# ***DOCKET ITEM #11***

## ***Coordinated Development District Conceptual Design Plan #2021-00002***

### ***Development Special Use Permit #2021-10019***

### ***Eisenhower East Block 32 / Carlyle Plaza Two Amendment – 760 John Carlyle Street, 1700 & 1800 Eisenhower Avenue, 800 Bartholomew Street***

*Figure 15. Areas Where a Street Tree Modification is Acceptable (in pink)*

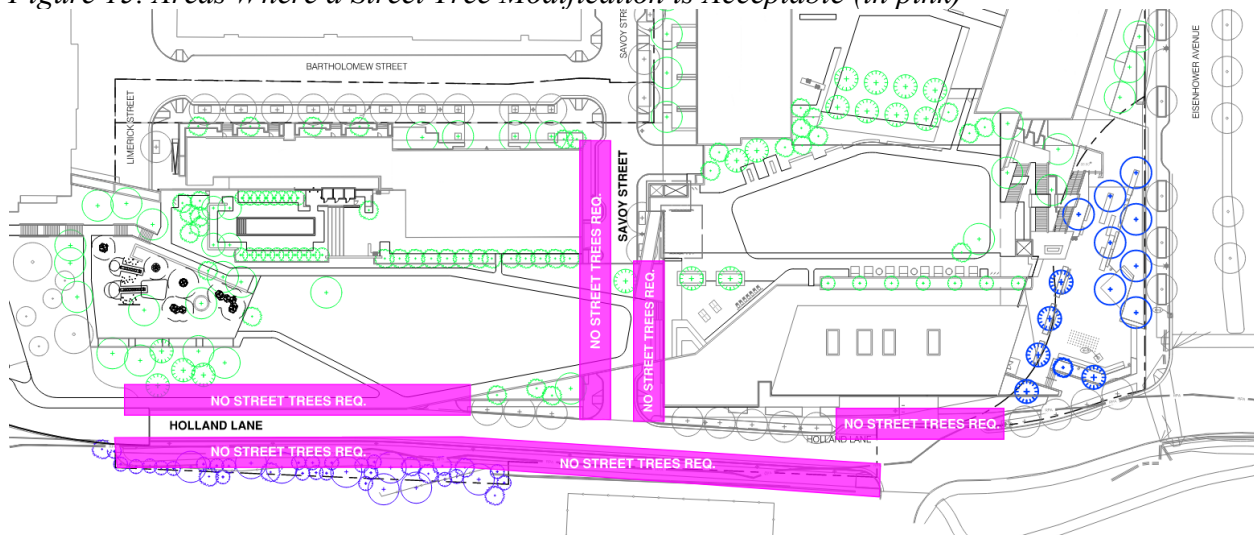
The applicant is requesting a modification to the street tree requirements outlined in the 2019 Landscape Guidelines. Per the guidelines, projects that require a Development Special Use Permit (DSUP) approval require one street tree for every thirty (30) feet of lot frontage along the public right of way, with a minimum of one per frontage. The applicant is not meeting this requirement for areas along Savoy Street and Holland Lane due to confined street sections along Holland Lane and underground utilities and the unsupportive growing environment created by the open space bridge above Savoy Street. The applicant is requesting a reduction of the total street trees for the areas not including street trees as shown on the Preliminary Plans and highlighted in Figure 15, below. Staff would like the applicant to provide street trees on Savoy Street, if possible, and has included Condition #12h, which states that “the applicant shall work with City Staff to provide additional street tree plantings where feasible”. The applicant is meeting the required 25% minimum canopy coverage requirement by providing 42% canopy coverage on the property.

## MOD. CG-3

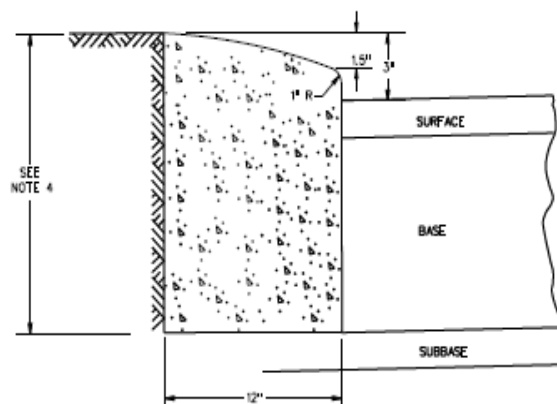
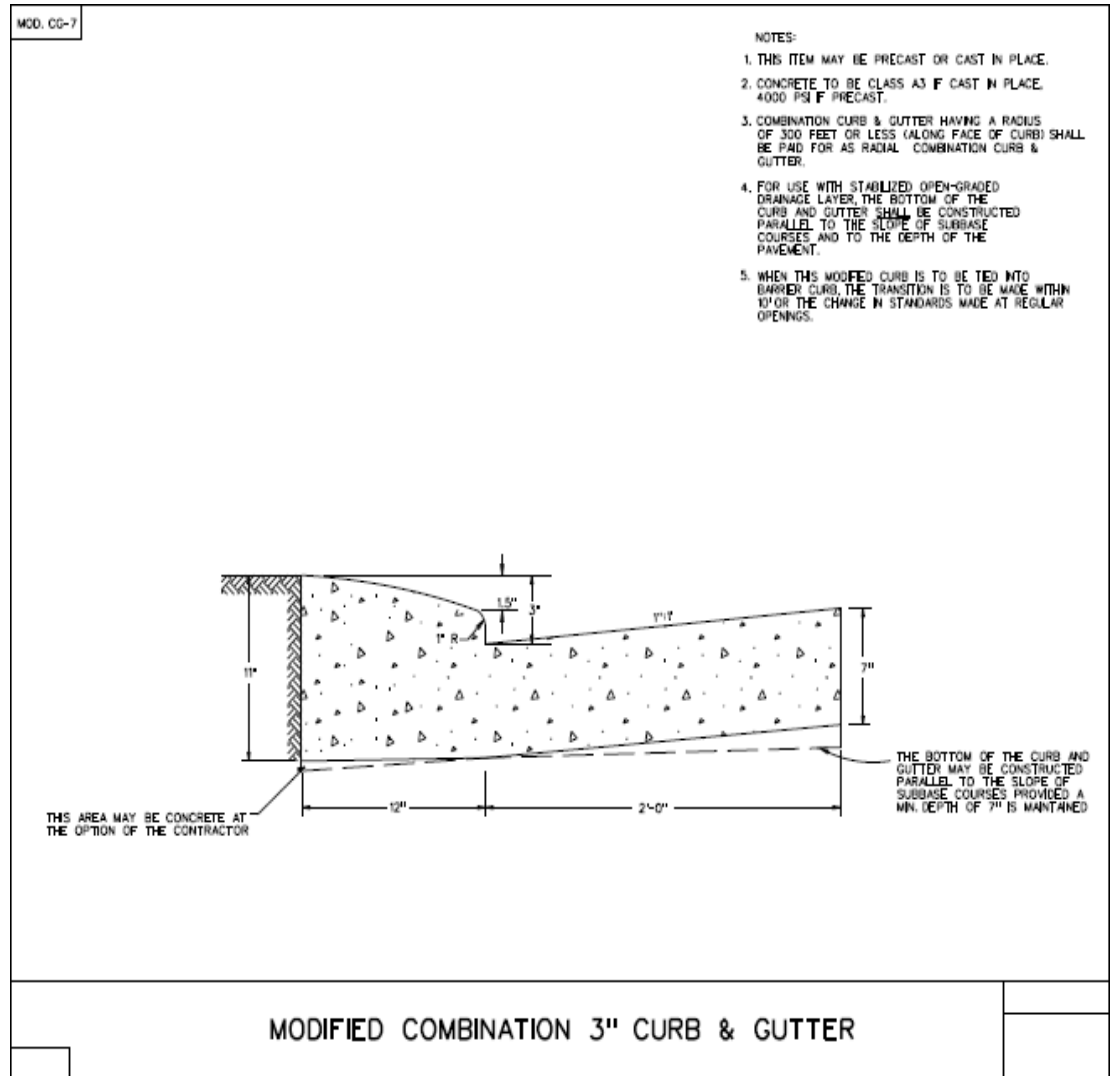
Where curbing is a component of the emergency vehicle easement, the curbing construction shall conform to weight and grade requirements for vehicular traffic. In no circumstances shall a raised curb be located in the path of travel in an emergency vehicle easement. Where a mountable curb is provided as part of an emergency vehicle easement, emergency vehicle easement signs shall be posted at the point nearest the edge of the emergency vehicle easement, but in no case within the clear width of the emergency vehicle easement. With the exception of flush curbs, any fire department access points that require fire apparatus to mount a curb shall conform to the modified 3 inch curb design standard MOD CG-3 or MOD CG-7 design as shown.

EVE's are proposed in sign locations have been added to drawings.
